#### **ADDENDUM NUMBER 3**

DATE: December 5, 2016

BID NAME: REPLACEMENT OF VICTORY VILLA ELEMENTARY SCHOOL

BID NUMBER: ARA-209-17

C2.01

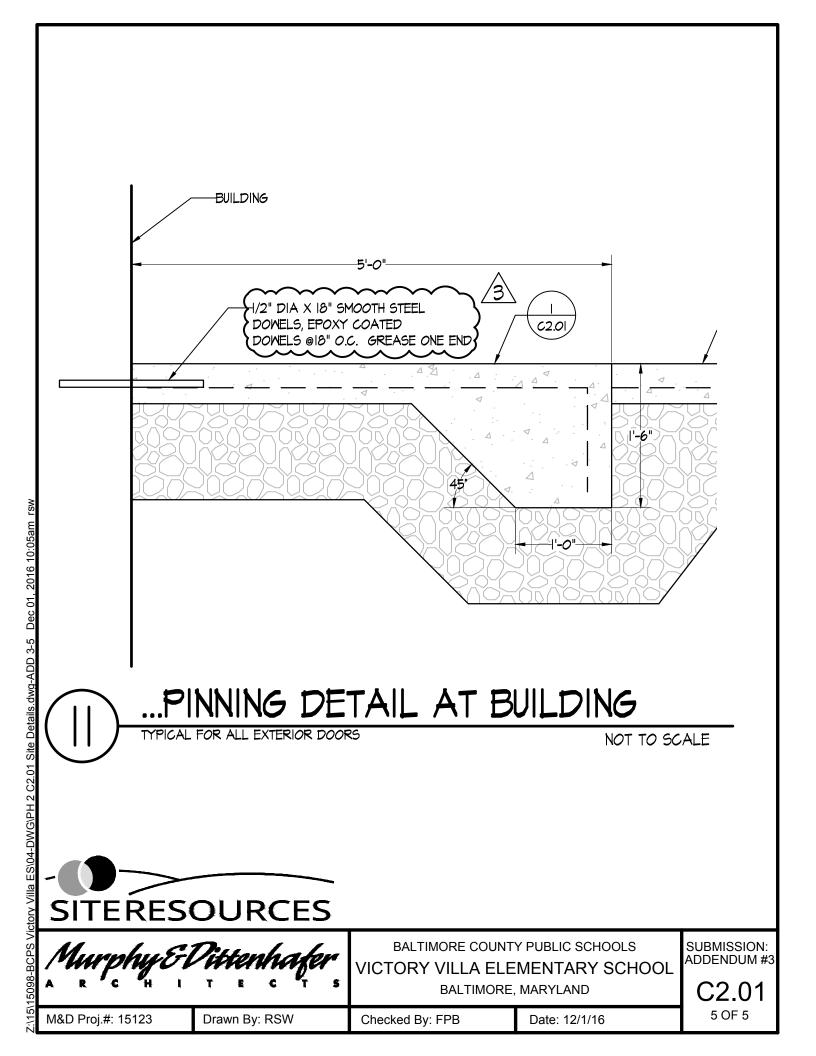
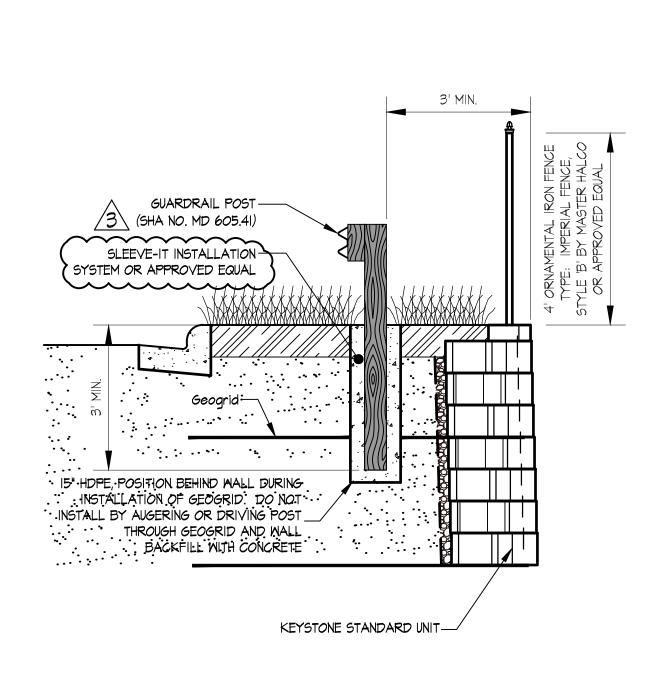
#### **REVISE SHEET C2.01**

**ADD:** Epoxy coating to all welded wire, fabric, steel dowels, any rebar, noted in details # 1,4,5,9, and 11.

C2.02

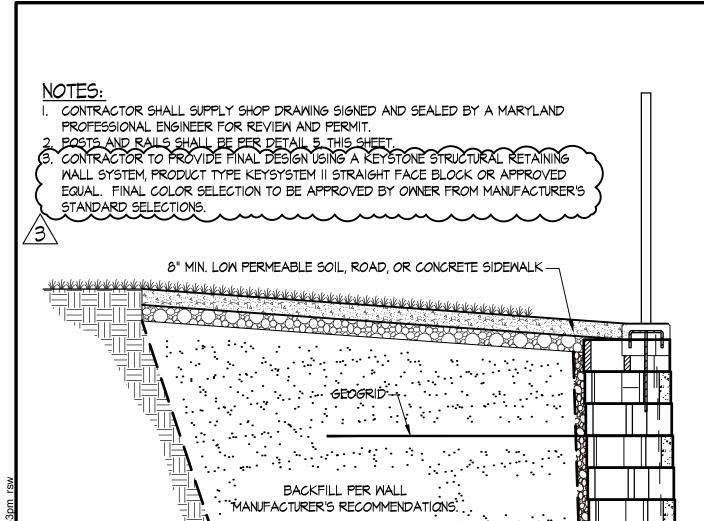
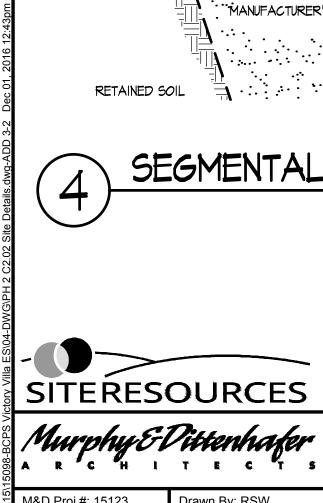
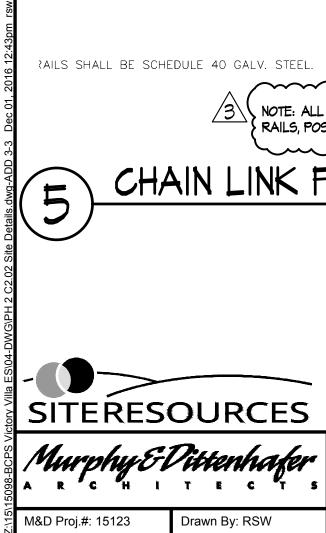
#### **REVISE SHEET C2.02**

**ADD:** Note to detail #3: Sleeve-It, foundation system or an approved equal.

**ADD:** Note to detail #5: All fence fabric shall have a black vinyl coating. All fence rails, posts, and hardware shall have a black powder coat finish.

**ADD:** Note to detail #4, keystone structure retaining wall system, product type Keysystem II Straight face block, or approved equal. Final color selection to be approved by owner from manufacturer's standard selection.

C2.03

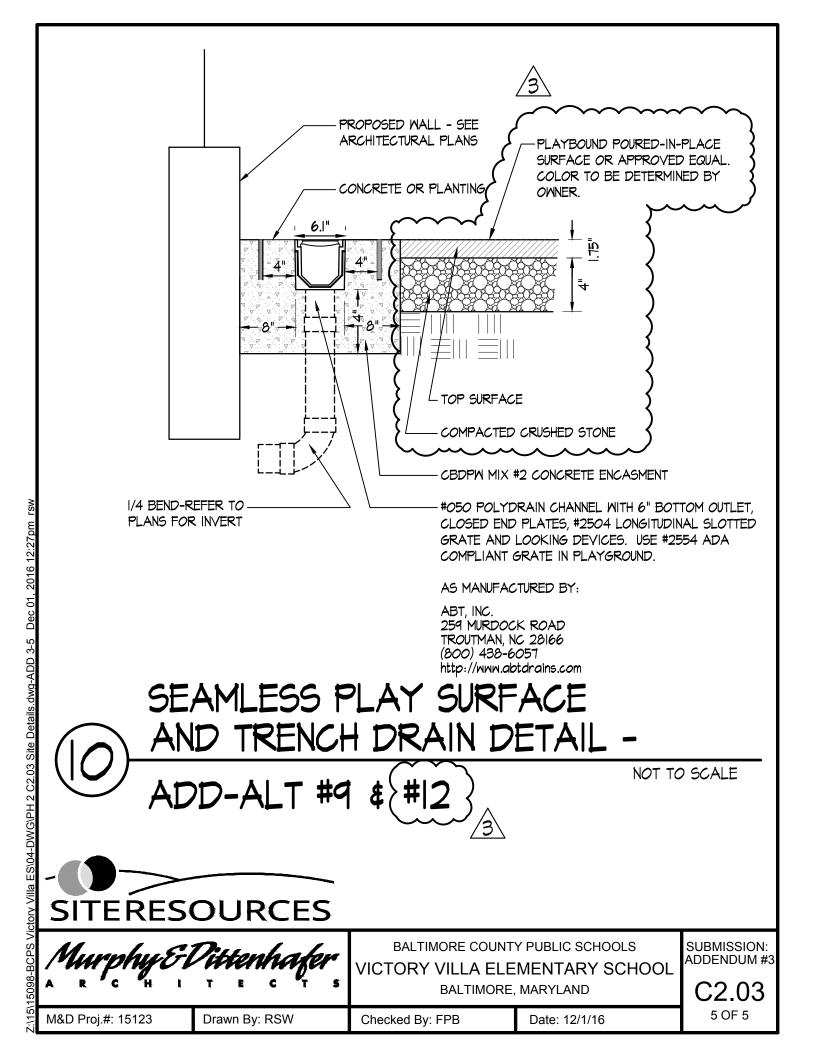
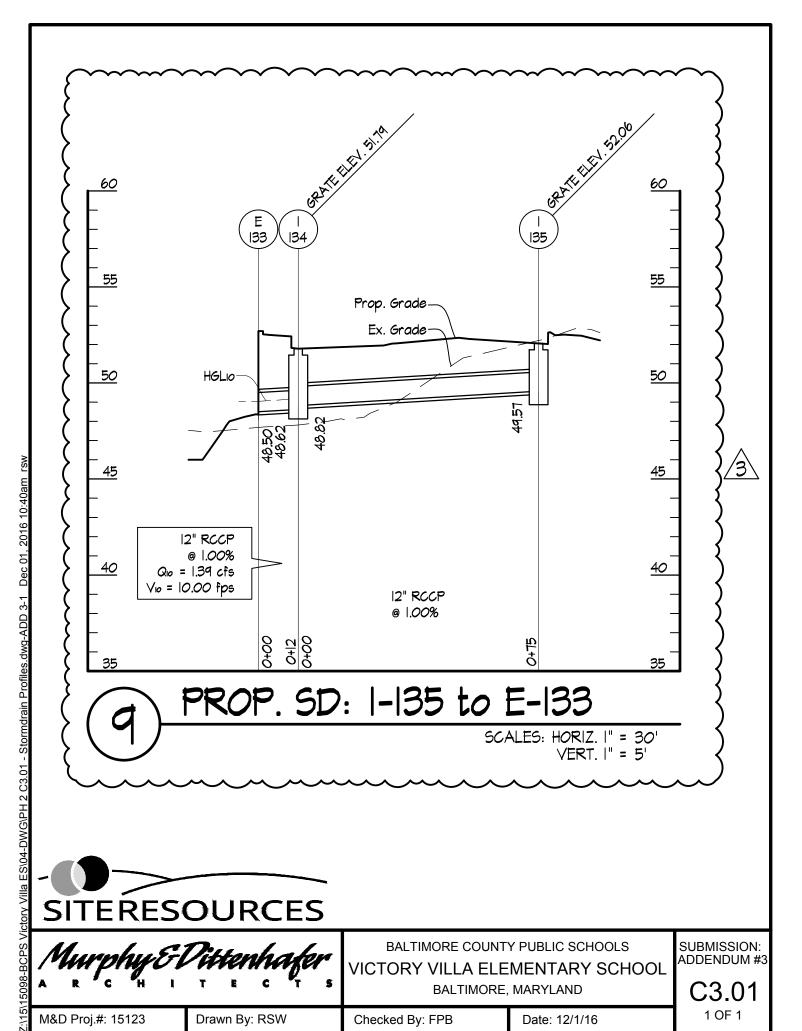
#### **REVISE SHEET C2.03**

Delete: Detail #4.

**DELETE:** ADD-ALT from detail #5.

**ADD:** Base bid to detail #5.

**DELETE:** Base bid from detail #6.

ADD: ADD-ALT #10 to detail #6.

**DELETE:** ADD-ALT from detail #7.

**ADD:** Base bid to detail #7.

ADD: ADD-ALT #12 and seamless play surface detail to detail #10.

(18) INQUIRY: Detail 5/C2.03 is noted as Alt #10, and detail 6/C2.03 as Base Bid. From the information on drawing C1.02 (notes C-17 & C-18) it appears that the Base Bid and Alt #10 designations should be reversed on details 5,6/C2.03. Please advise.

RESPONSE: Detail 5/C2.03 change to base bid, detail 6/C2.03 change to Add- Alt. #10
